SPECIAL INFORMATION LEAFLET No. 864A
(Superseding Special Information Leaflet No. 864)
SAFETY

A. SHOULDER HARNESS HARLEY BUCKLES FOUND DETACHED FROM MAIN HARNESS

SERVICE BULLETIN – IGQSB033 Issue 2

Self-Locking Buckles, Harley Type

Fig 1 - Self Locking Buckle, Harley Type

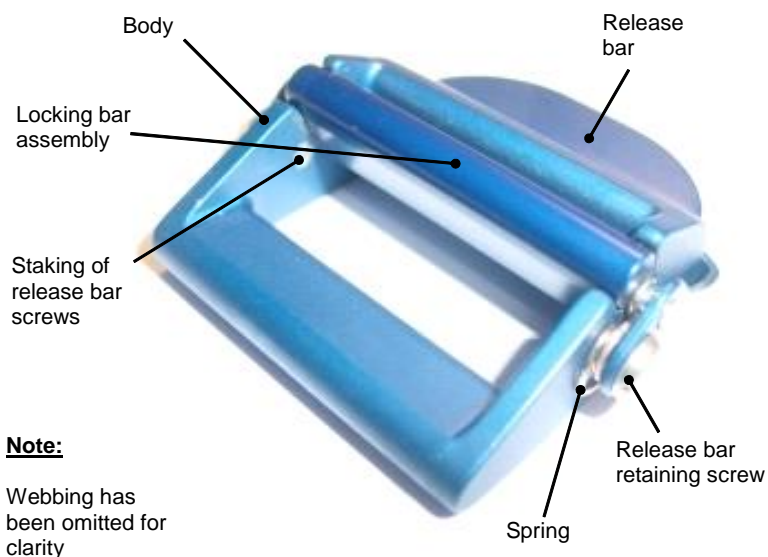
- (1) Procedures to inspect the listed buckled/associated IrvinGQ Limited manufactured assemblies before next use:
 - (a) Identify the two release bar retaining screws, one each side of the buckle (Fig 1).

- (b) Using a flat blade torque-setting screwdriver set to **9lbf.in (1.02Nm)**, attempt to remove each release bar retaining screw in turn by rotating in an anti-clockwise direction. If no movement occurs, no further action is required.

NOTE: The original torque setting of 12lbf.in (1.36Nm) detailed within IGQSB033 Issue 1 has been reviewed by IrvinGQ and reduced to **9lbf.in (1.02Nm)**.

Fig 2 – Spring in correct position

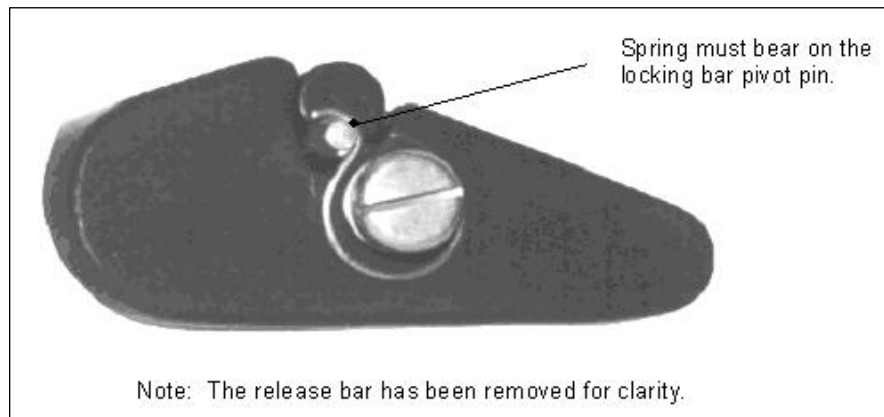
- (2) If following completion of the above procedure, movement of either of the release bar retaining screws occurs, **stop immediately**. The following rectification action is then to be completed:
- (c) Using a flat blade torque-setting screwdriver, set to **6lbf.in (0.68Nm)**, tighten each of the loose release bar screw(s), ensuring that the spring is retained in its correct position (Fig 2).

Note: The use of a small flat blade screwdriver may be required to assist with holding the spring correctly in place on the locking bar pivot pin (Fig 3).

Fig 4 – Staking/Peening Tool

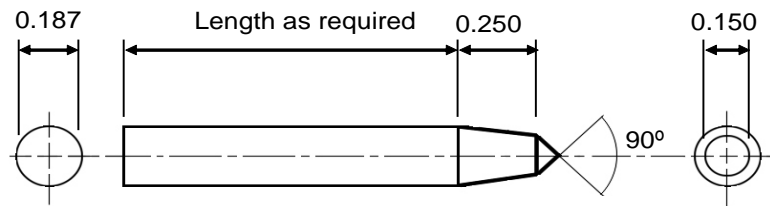
- (d) Place the head of the screw on a smooth steel plate. Expose the end of the screw thread on the inside face of the buckle body by loosening any webbing and moving the locking bar clear of the screw thread.
- (e) Using a locally manufactured staking/peening tool (See Table 1/Fig 4) and a light hammer, lock the screw and the buckle body together by staking/peening at two points, diametrically opposite each other and at 90° to any original staking/peening marks.

NOTE: A series of light blows/taps of the light hammer is recommended (opposed to a single heavy blow).
